APPENDIX 4.4

EPD's Agreement on Noise Assessment Points

**EIA Study for Mui Wo Lai Chi Yuen Cemetery Extension (ESB-288/2015)
Agreement on Noise Assessment Area and Representative Noise Assessment Points**

SHEET TITLE
 LOCATIONS OF REPRESENTATIVE NOISE SENSITIVE RECEIVERS

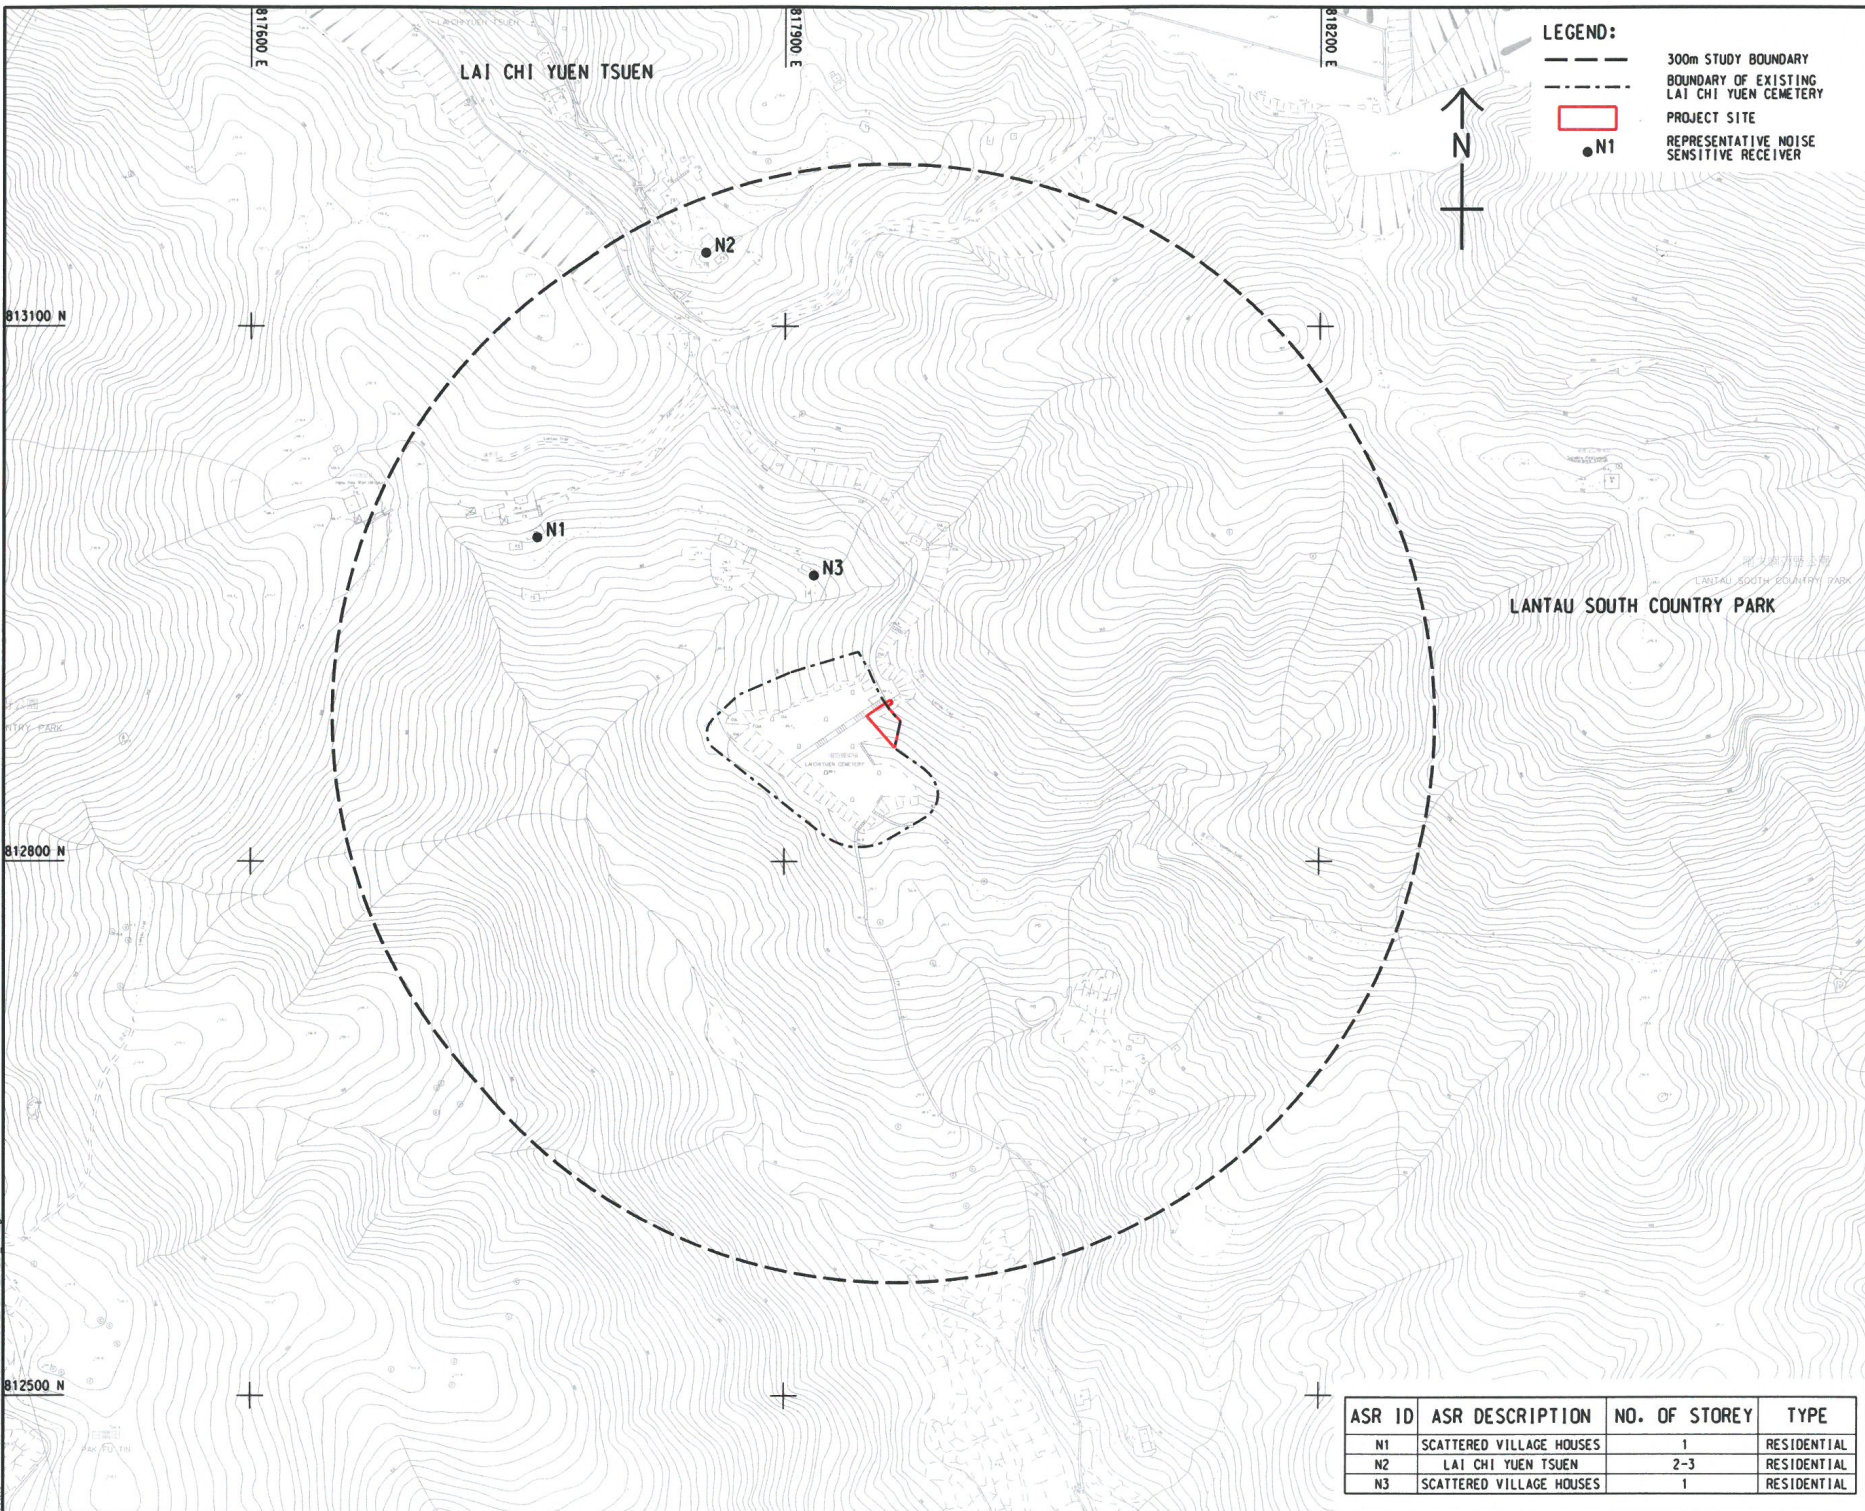
On noise aspect, we note the RTC (AECOM letter ref. 60453162.40033037/4503.324 dd. 7 April 2016 refers) indicates that the point N3 is assigned as assessment point hence we have no further comment.

We refer to your comments on the selected representative noise assessment points for the captioned EIA Study in our letter dated 28 October 2015 (our ref.: 40033037/445901) via email on 19 Nov 2015. The selected representative noise assessment points have been updated. We are pleased to enclose herewith a figure showing the boundary of assessment area, locations and descriptions of the updated representative noise assessment points (N1 to N3) for your agreement in accordance with Section 2.2.1 (a) & (c) and Section 3.2.1 (a) & (c) in Appendix B of the EIA Study Brief No. ESB-288/2015. Photographs of the updated representative noise sensitive receivers are also enclosed for your information.

Annex 2 Aerial Photograph of the Project Site and the Representative Noise Sensitive Receivers

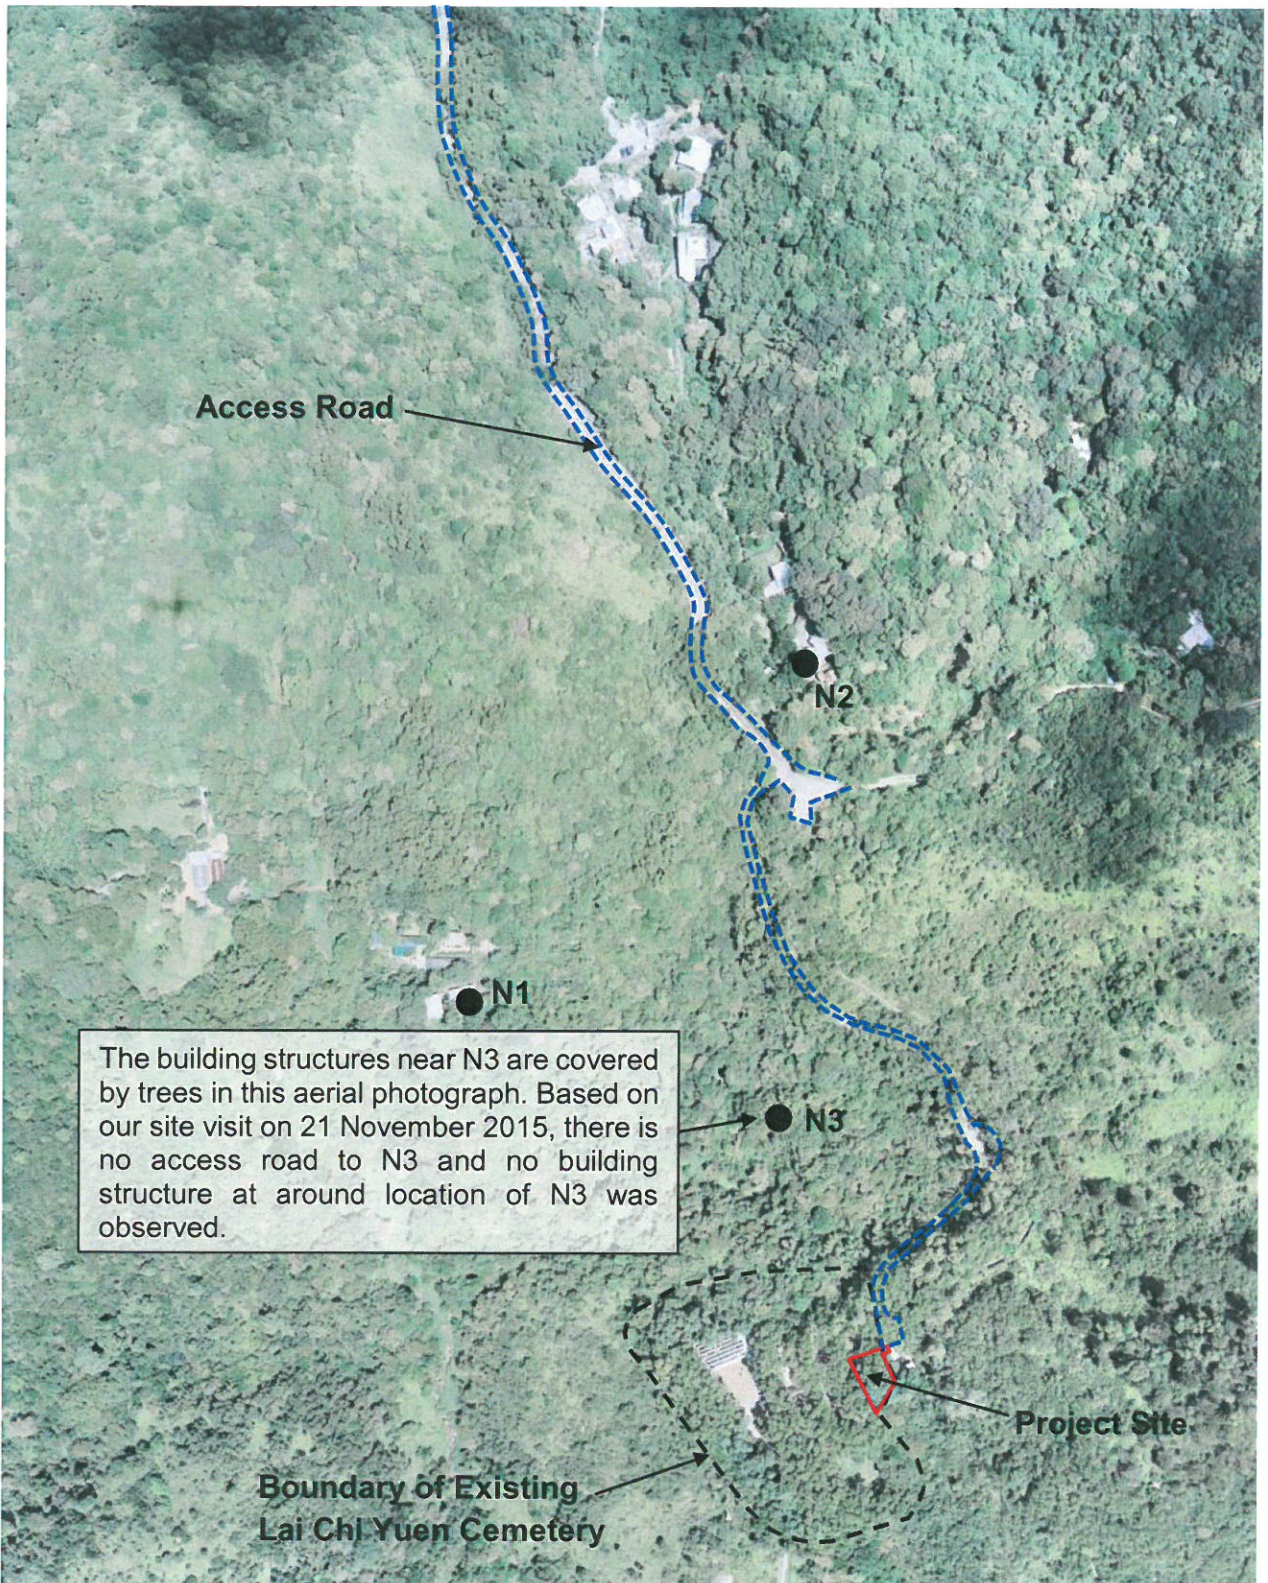
According to the land status information as indicated in your comments, there are some building structures near N3. Referring to aerial photograph, no potential building structures are found. Based on our further site visit on 21 November 2015, there was no access road to potential building structures around N3. Therefore, those building structures are believed to be deserted. Nonetheless, N3 is selected as a representative noise assessment point for these building structures under construction and operational noise assessments in this EIA Study to ensure that the Project would not cause any unacceptable adverse noise impacts to N3, in case these building structures are inhabited during the construction and operational phases of the Project.

N3 Scattered Village Houses (Taken on 21-Nov-2015)

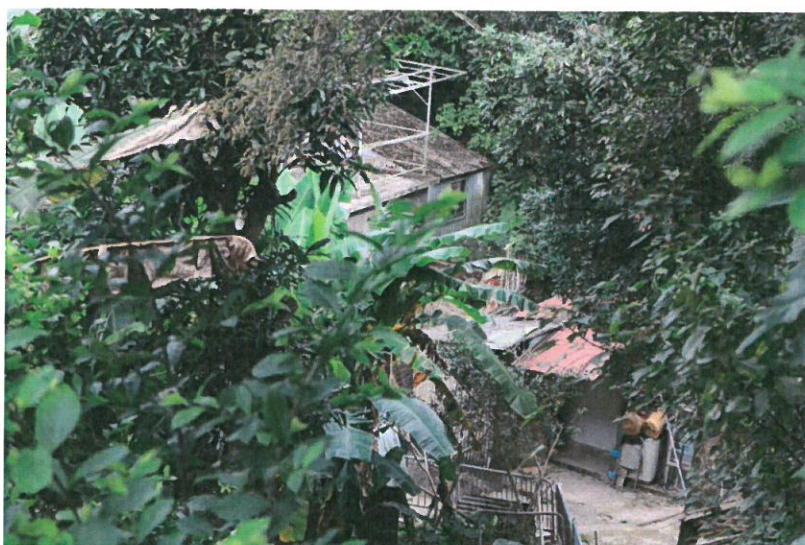
No building structure at around location of N3 was observed during site investigation and no access road to N3 is available.
